**PARTIAL PLAN-SPACE RESIDENCE**  
 1/4" = 1'-0"

RE: Proposed Addition at Woodmark lot 18, 12248 Pointer Hill Ct.

# SITE PLAN

Proposed Addition & Alterations for  
 Will & Sandra Speace  
 12248 Pointer Hill Ct.  
 Ellicott City Md.

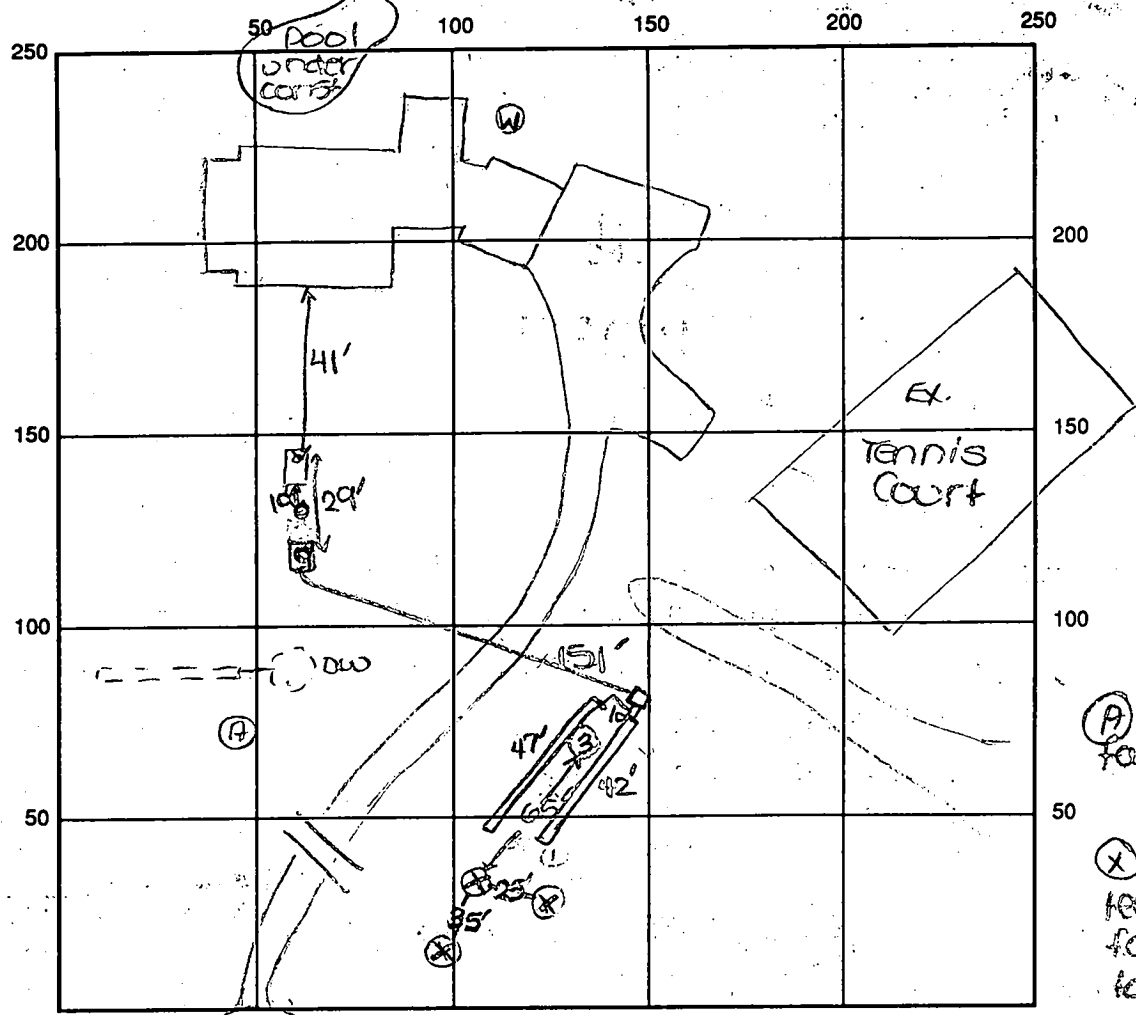
Install trenches in area of passed perc hole (3)  
trenches to be 6' wide, inlet 3', bottom 5', stone 2'  
\* system to be pumped, existing drywell to be  
abandoned. \*

REMARKS: 4/16/97 Perc hole ③ OK. Drywell to be abandoned.  
OK to begin work as specified. DKS/KRM  
4/18/97 OK to cover all septic work. Pump check  
needed. Drywell to be abandoned. DKS/KRM  
5/9/97 PUMP/ALARM OPERATION OK, ROBERT EYCK SAYS THAT  
DRYWELL WAS PUMPED + COLLAPSED

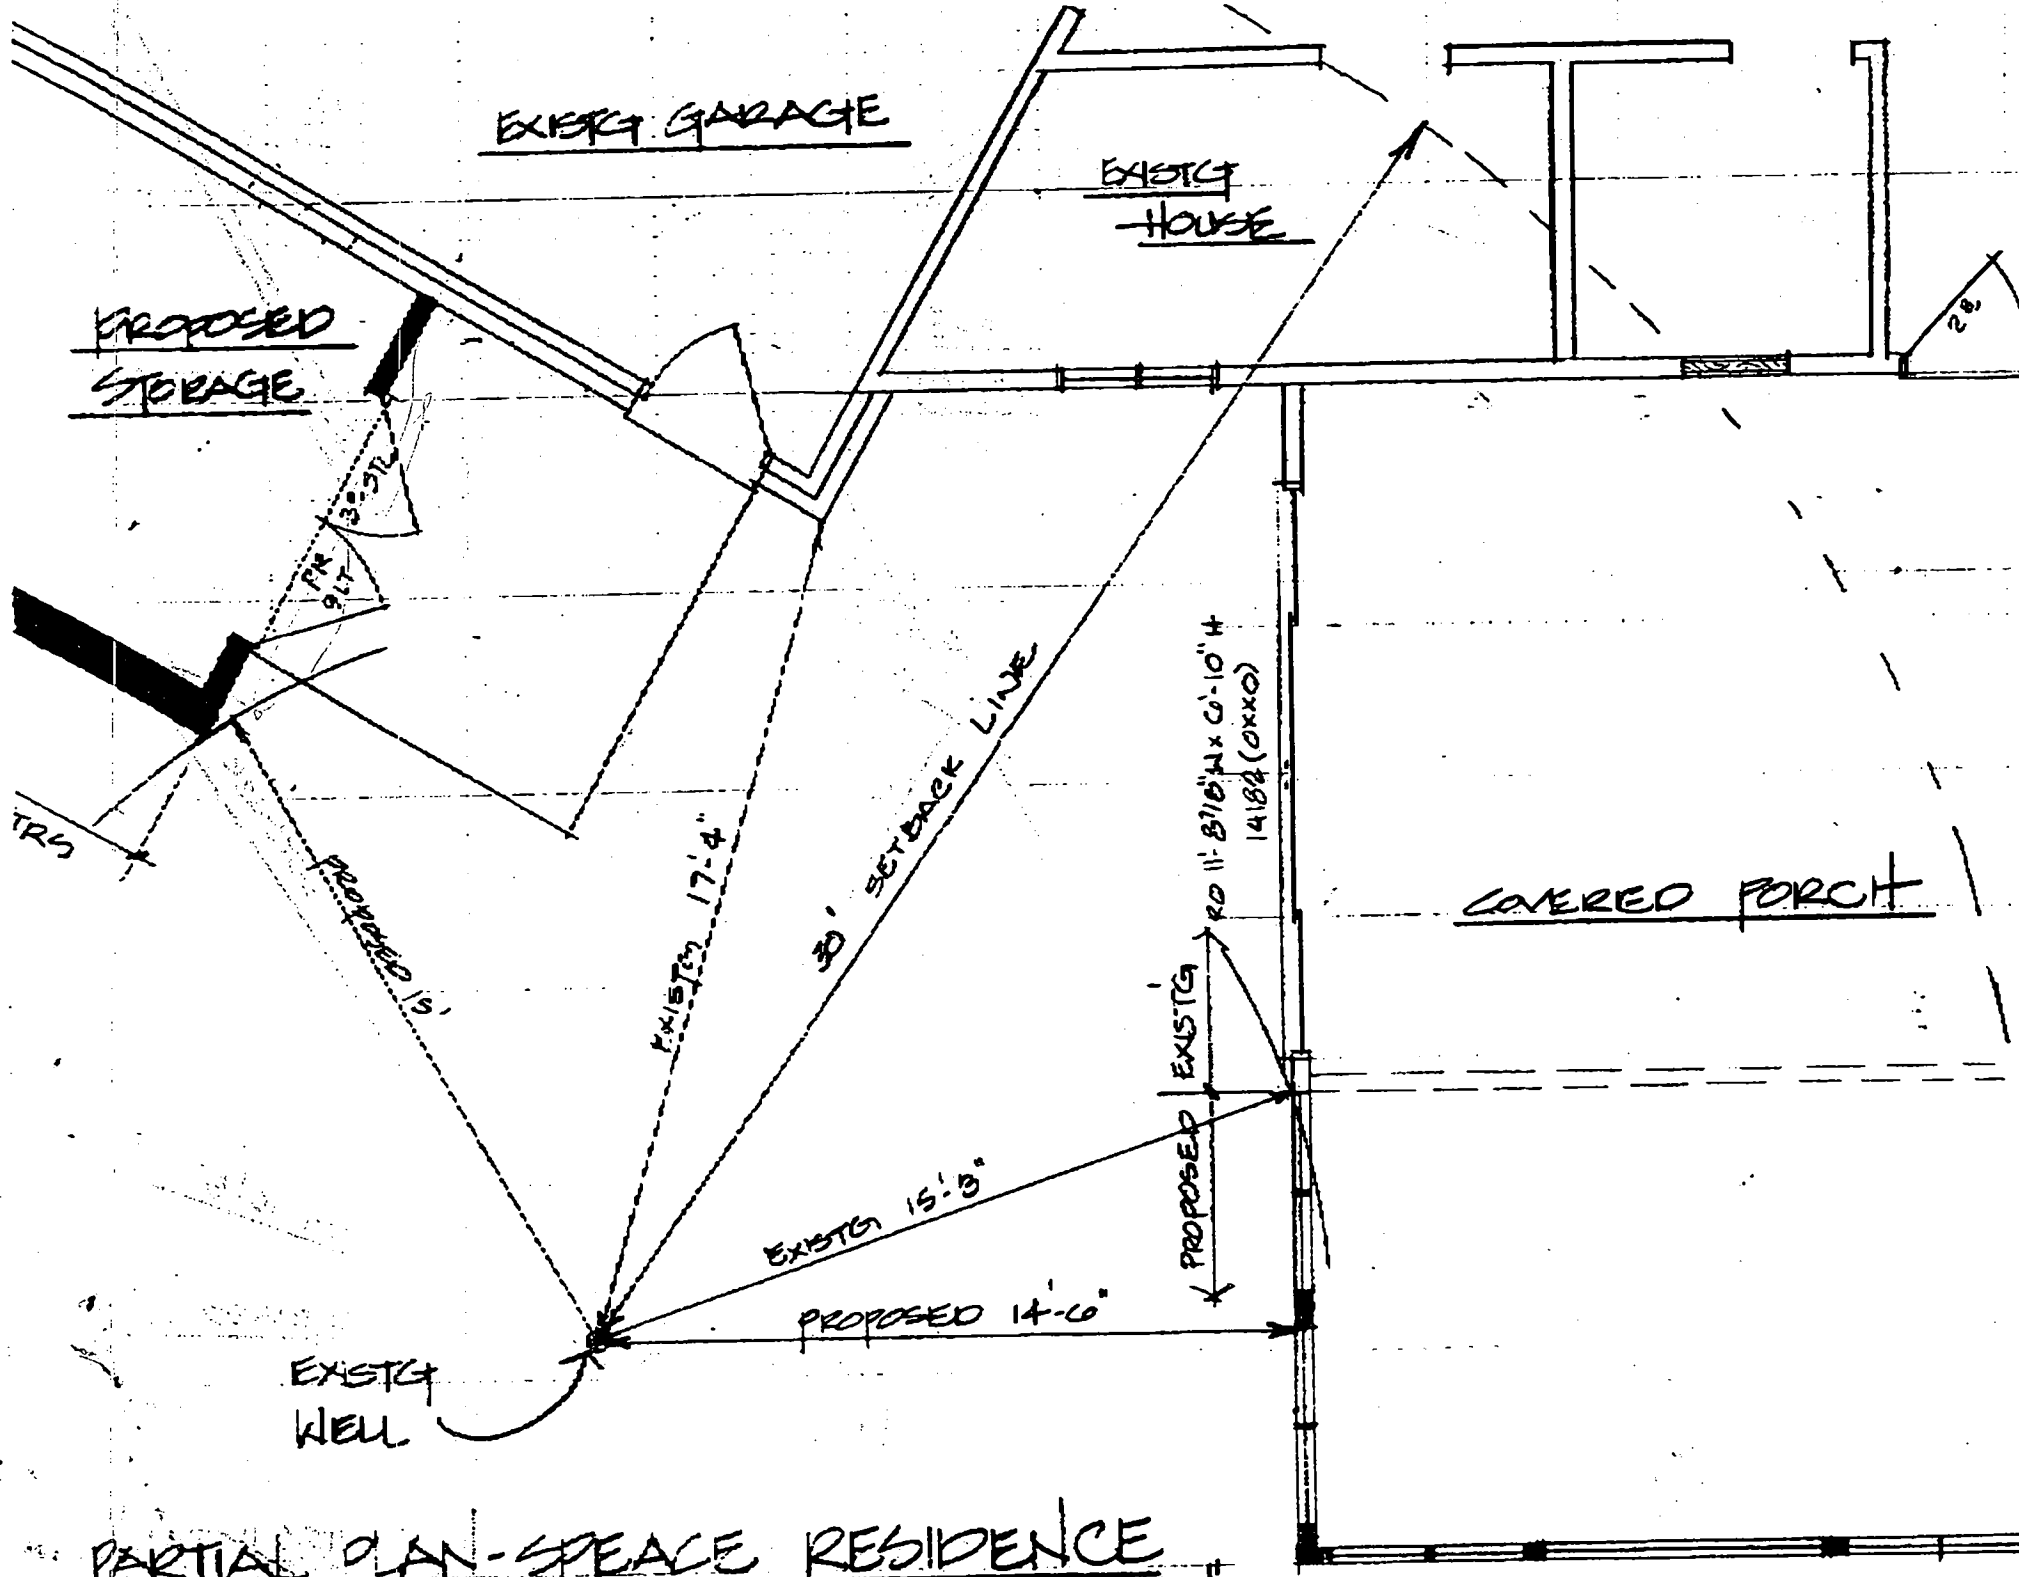
I am planning to convert a Screened-in-porch to a Sun Room and extend it 10'-0" at my residence listed above. A storage shed is also planned to be connected to the garage, both to be on concrete slab. Sinex Design (410-964-2554) is doing the architectural plans. The reason for this letter is to request your review for possible approval of the change in distance from the well to the proposed new construction.

Attached is a drawing of the existing and proposed building lines with distances to the well. The well is 280' deep. Since there is such a small difference in distance to the well with the plan, I don't see any problem from my point of view. The house was built in November 1981.

The site plan submitted with your building permit shows the well to be 15'3" from the closest structure. Since this separation is substantially closer than the current standard, no further reduction will be permitted by this office.

This office has received your request for a reduction in the 30' separation specified in the state well construction regulations, between a well and a structure. See COMAR 26.04.04.05.

For protection of the well, this office prefers that all new structures be at least 30' from a well. In the case of older construction where a reduced setback already exists, that distance shall serve as the minimum allowable separation for new construction.

If you believe this determination is incorrect, this decision is subject to review. Such a request should be directed in writing to the Bureau Director and should include information that you feel is sufficient to warrant a reconsideration of our decision.

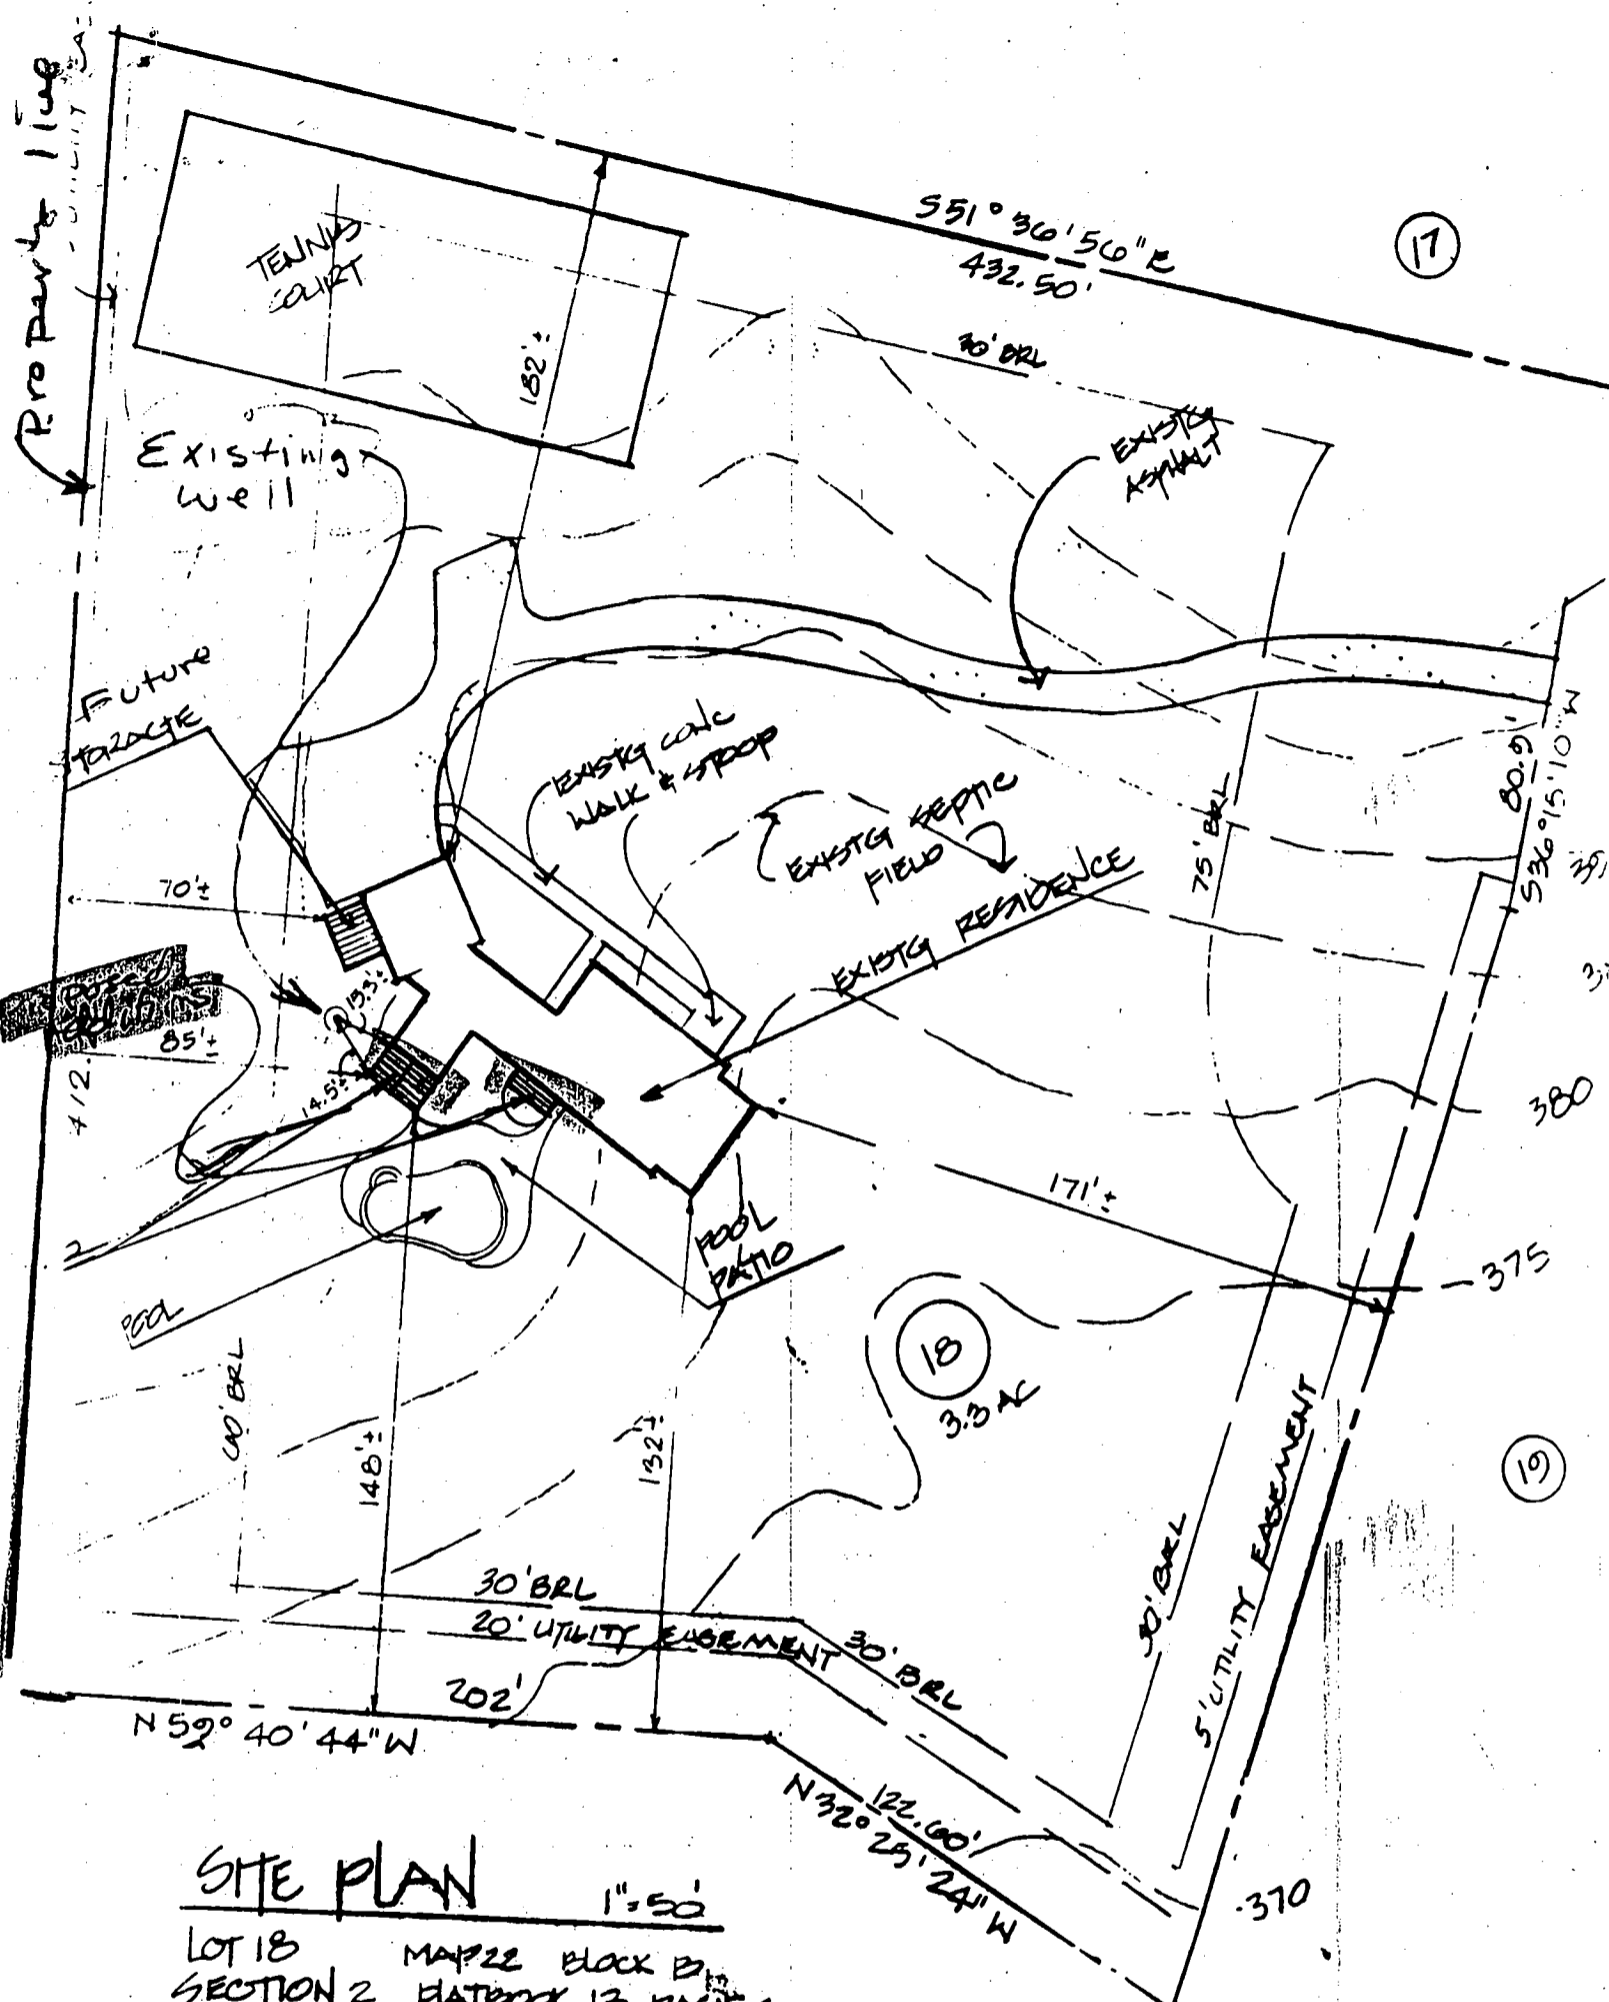
SEE OVER  
FOR CONTRACTOR'S REPLY.  
HEALTH DEPT FINAL RESPONSE.

CONCERNS ARE RESOLVED  
PER CONTRACTOR'S CLARIFICATION OF CONSTRUCTION DETAIL.  
WILL BE RECOMMENDED FOR APPROVAL

Classification of method of construction;  
Termite proof materials & construction  
methods are to be used in the addition  
and in the remodeling of the attached  
portion of the house to a distance of <sup>well</sup>  
25' or more from the existing ~~house~~.
